Zoning Board of Appeals Agenda

To: Zoning Board of Appeals
From: Zoning Administrator Richard Peters
Date: 2026-08-24
Subject: DOCKET NO. ZBA26-0007 (1235 SUNSET RIDGE Road) Petition by Ryan Wiley and Dorothy Lasauskas, for a variance to allow the installation of a six-foot-tall fence in the front yard setback. The R-5 zoned property (PIN: 04-12-300-018-0000) is restricted to a 4-foot-tall fence within the front yard. The relief is intended to address safety concerns along Sunset Ridge.

ZONING BOARD OF APPEALS - STAFF REPORT

DOCKET NUMBER: ZBA26-0007

Figure 2: Fence Plan, Excerpt (proposed in red)

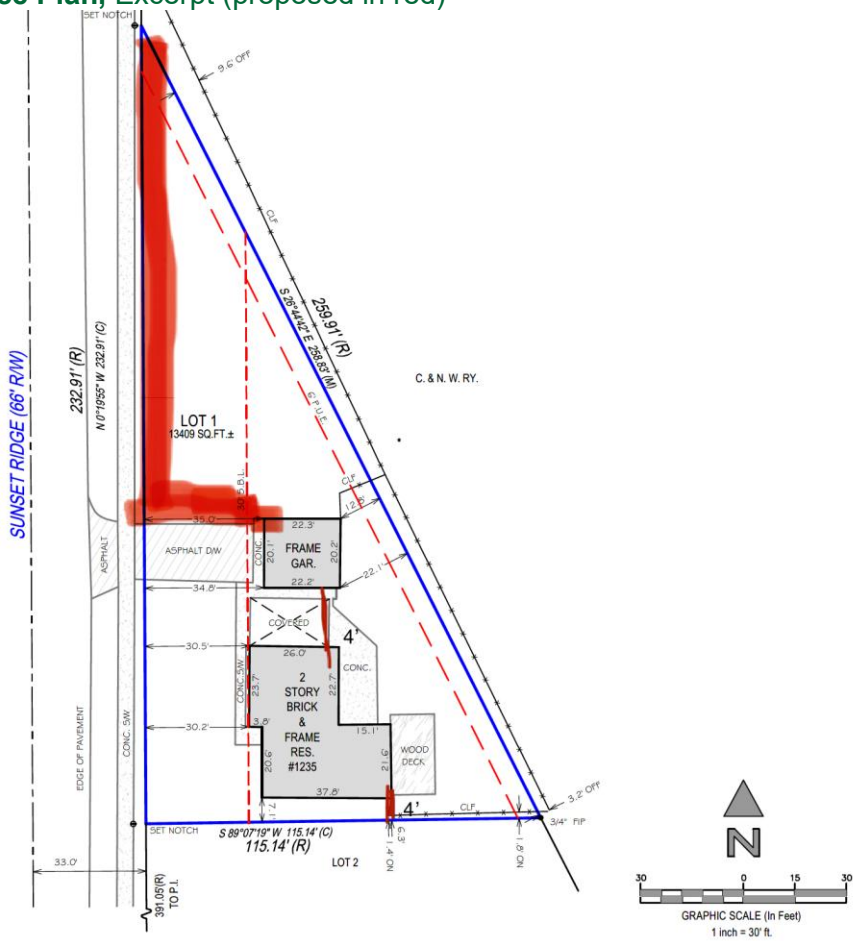
The Zoning Board may wish to discuss whether the request is commensurate to the difficulties presented by the irregular shape, or if less relief would be appropriate with respect to location of a 6-ft. fence in the front yard (i.e., a location within the front yard setback where a 6-ft. fence would be granted rather than up to the property line). Consideration should also be made to the wall of arborvitae located along the front property line. It is unclear if the fence will be installed in front of, or behind the hedge row.
